March 12, 2018
BOARD OF COUNTY COMMISSIONERS
ORANGE COUNTY, FLORIDA

IFB Y18-729-TA, ADDENDUM NO. 5

**SOUTH WATER RECLAMATION FACILITY (SWRF) INFLUENT PUMP STATION
IMPROVEMENTS**

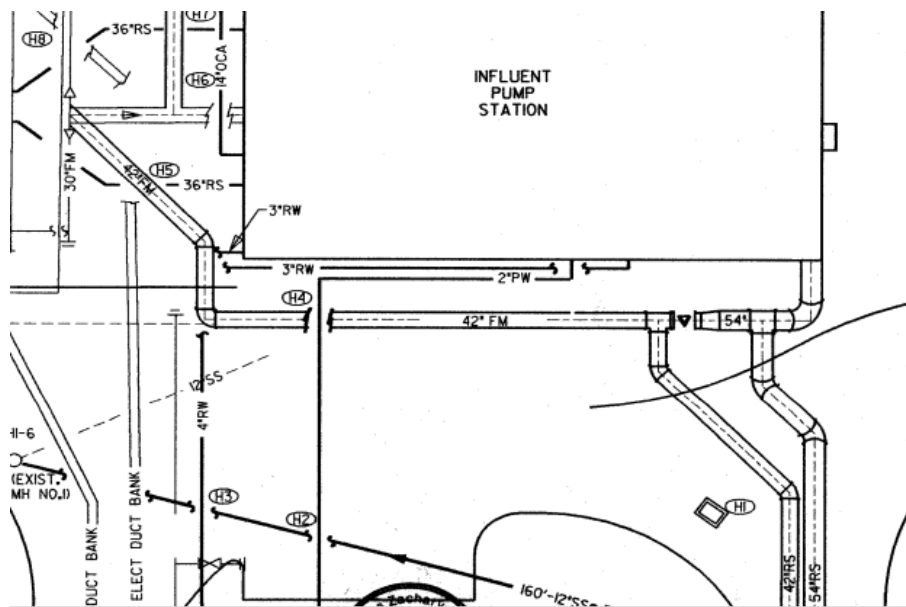
- C-35 New Yard Piping Partial Plan "H" shows a completely different piping configuration for the 54" exiting the SE corner of the Existing IPS. Please see a picture below. If this is truly the piping configuration, it may be impossible to perform the Linestops and Hot Taps as shown on the Bid Documents. Can we confirm the piping configuration?

Response No. 4: The drawings provided Addendum #3 should not be considered as as-built or record drawings. All Bidders are required per Part C – INSTRUCTION TO BIDDERS, 2. (k), to carefully examine the site of the proposed work and make all necessary investigation to inform themselves thoroughly as to all difficulties involved in the completion of all work required pursuant to the mandates and requirement of this bid package.

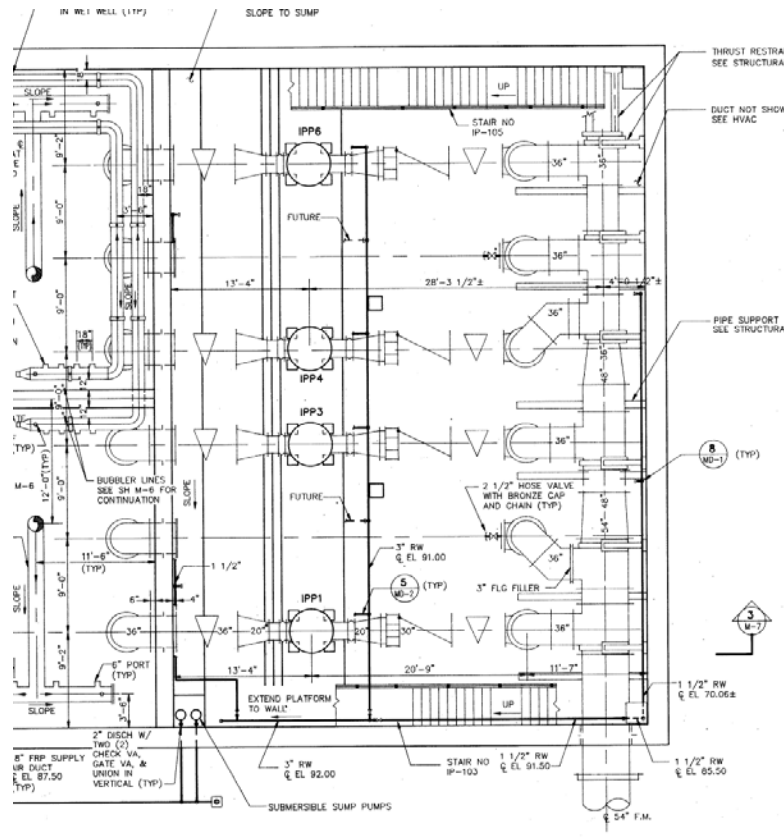
9. There are a couple notes on Drawing M-8 about the 30" x 24" Riser Pipes. They do not show any supports on the risers but the notes below suggest that some are required. There are no details or design criteria for the pipe supports. How do we include a cost in our Bid for the supports if we have no information on quantity, locations, purpose or design requirements?

Response No. 9: Note 1 states, "DISCHARGE PIPING PIPE SUPPORTS IN WET WELLS TO BE DESIGNED AND SIGNED/SEALED BY PE FLORIDA STATE STRUCTURAL ENGINEER." The piping support design (support type, connection, spacing, etc.) shall be based on the structural engineer's calculations to support the discharge piping based on piping length, loads and other factors that contribute to the support design.

See Specification Section 15126 FOR THE PROJECT REQUIREMENTS for piping support.

ORANGE COUNTY SOUTH WATER RECLAMATION FACILITY INFLUENT PUMP STATION MECHANICAL EXISTING IPS - DEMOLITION SECTION

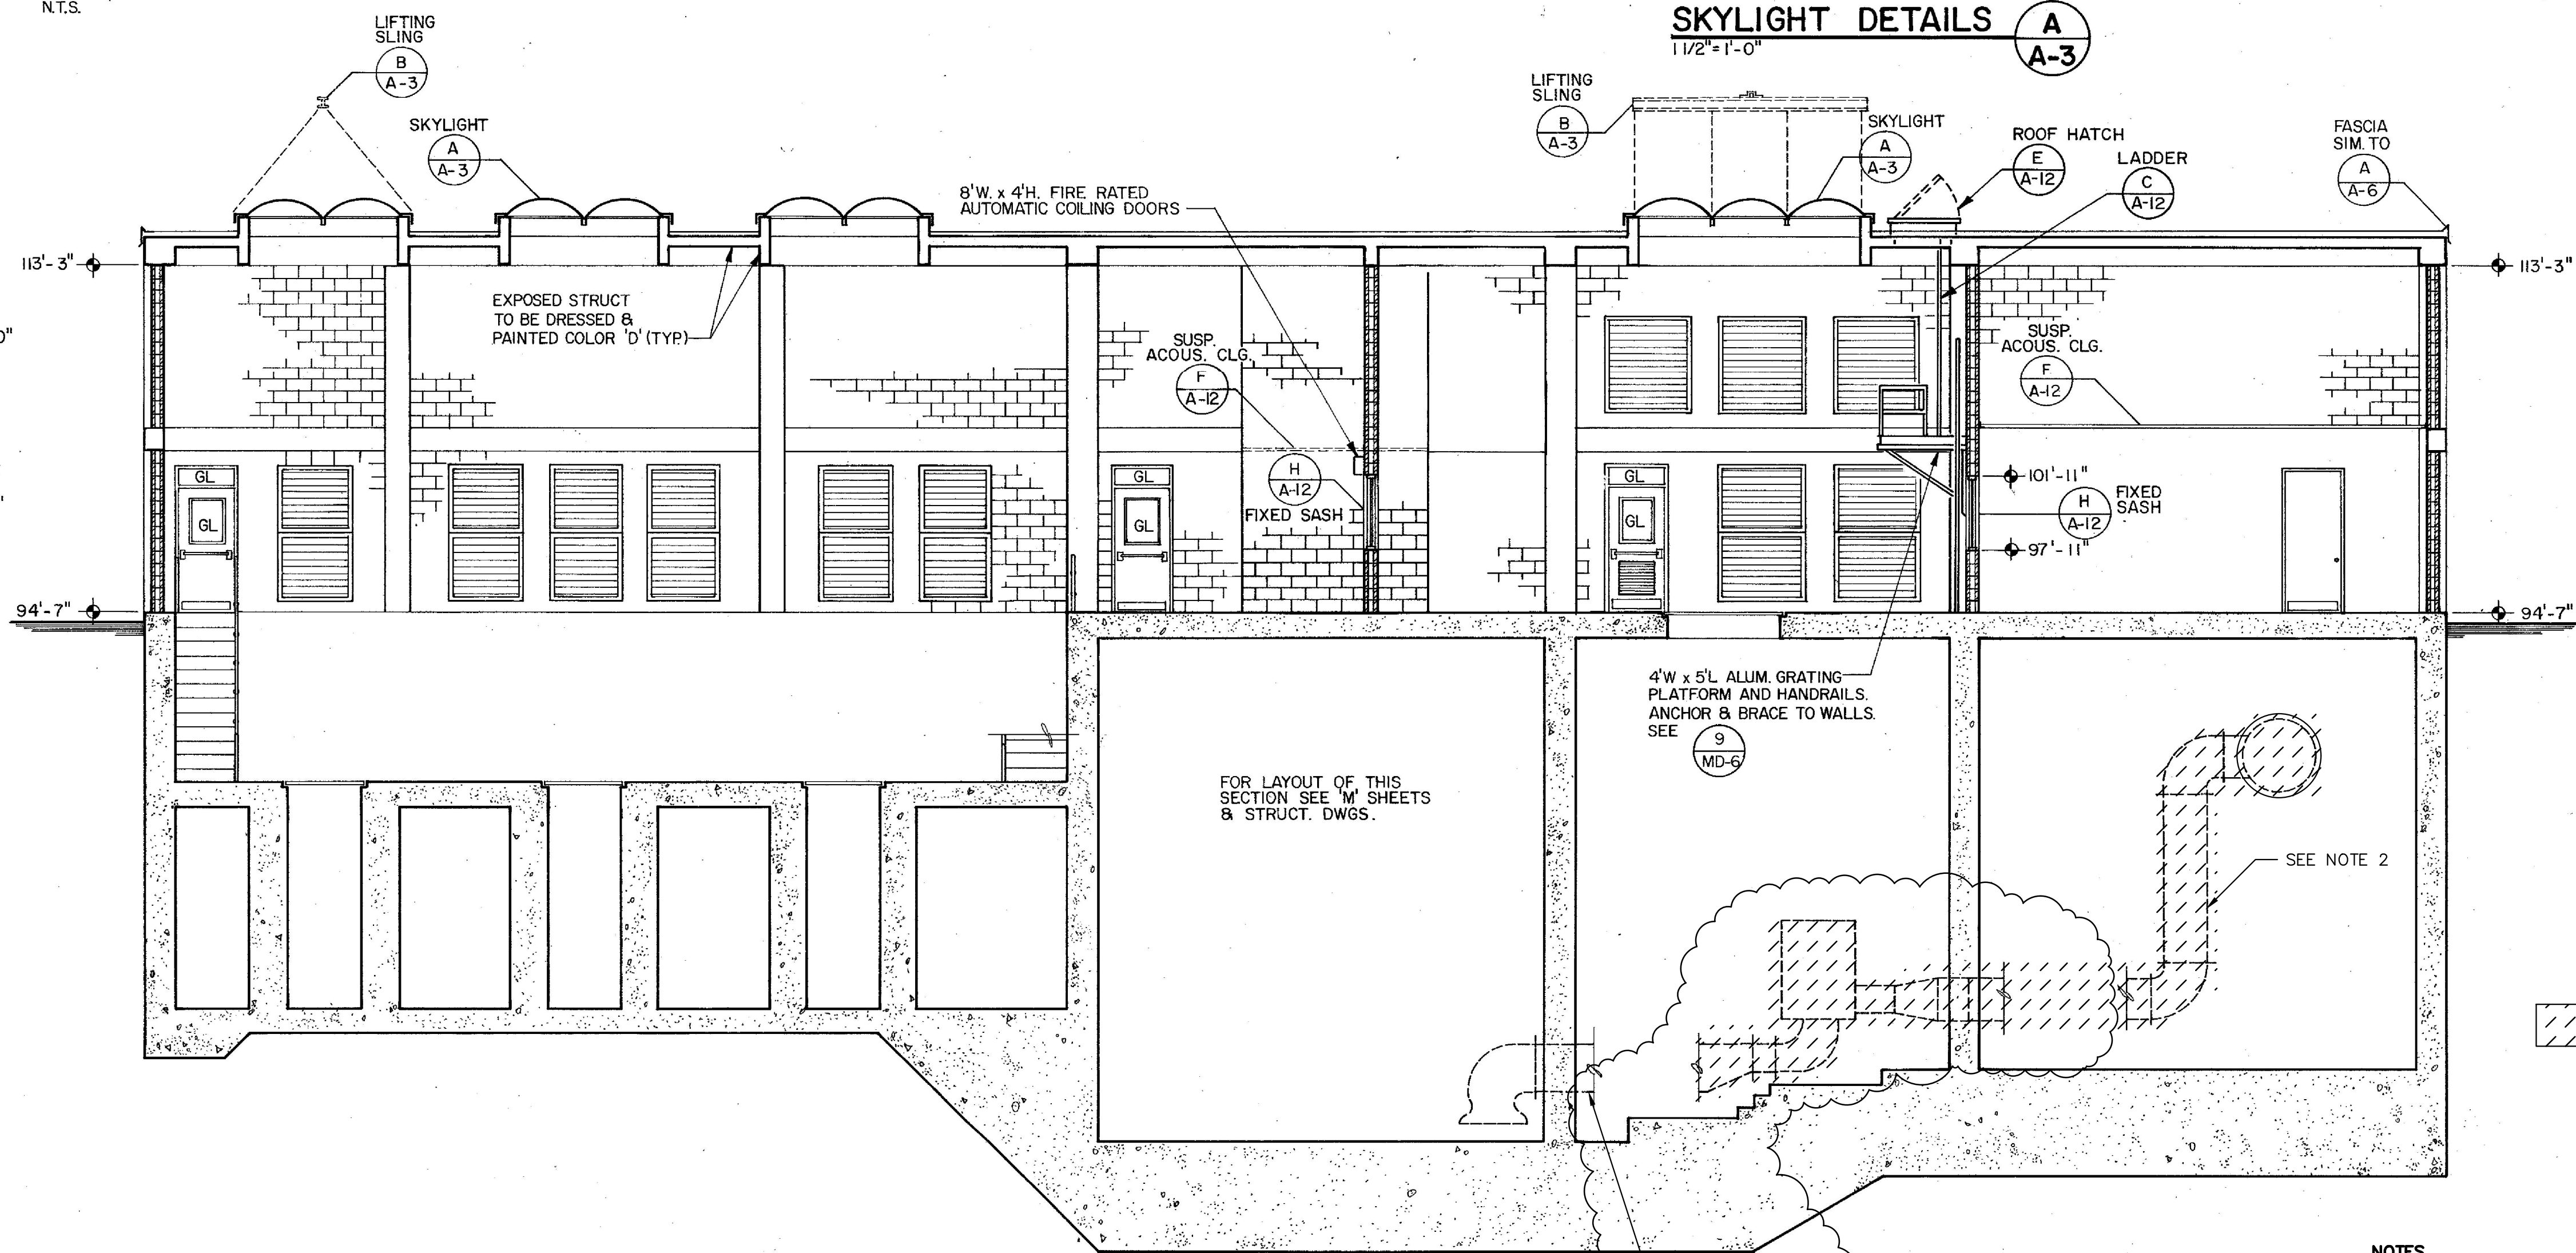
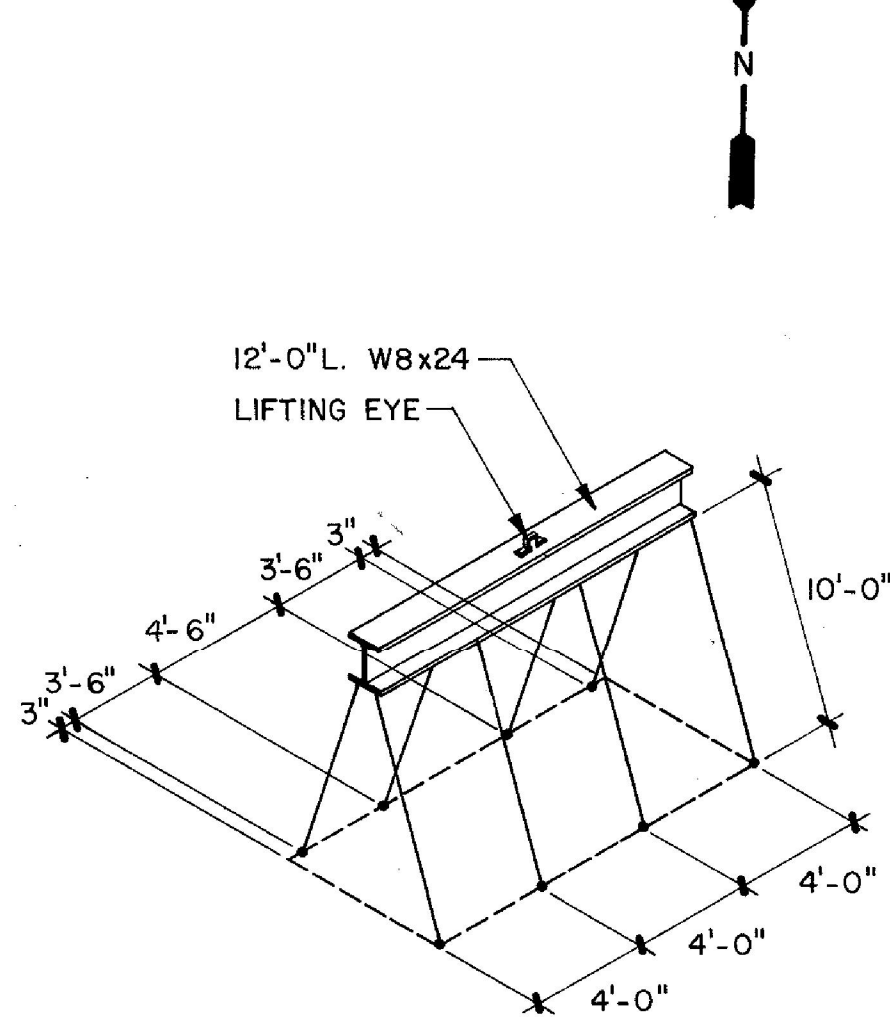
12. Can we get clarification on what is to be removed in the East end of the Existing Pump Station. M01 just has a generic note in the middle of the Existing Pump Station. M05 Note 2 says to Remove all equipment inside the pump room but only the piping and risers are hatched for demolition. Please see section Drawing M-5 from the Phase 3A Expansion. Can we get clearer limits and descriptions of what gets removed?

- REFERENCE DRAWING ONLY.
- ALL EQUIPMENT INSIDE PUMP ROOM INCLUDING, BUT NOT LIMITED TO, PUMP PIPING, DRIVE SHAFTS, VALVES TO BE REMOVED ((TYP x4)).
- BLIND FLANGE TO BE INSTALLED AT VALVE REMOVAL.
- SEE INFORMATION FOR BIDDERS IN APPENDIX FOR PHOTOS.

Response No. 12: Drawing M05 has been reissued. See Note 2 on M05 and attached picture.

1. **Drawing M05 to be replaced in its entirety with the attached drawing.**
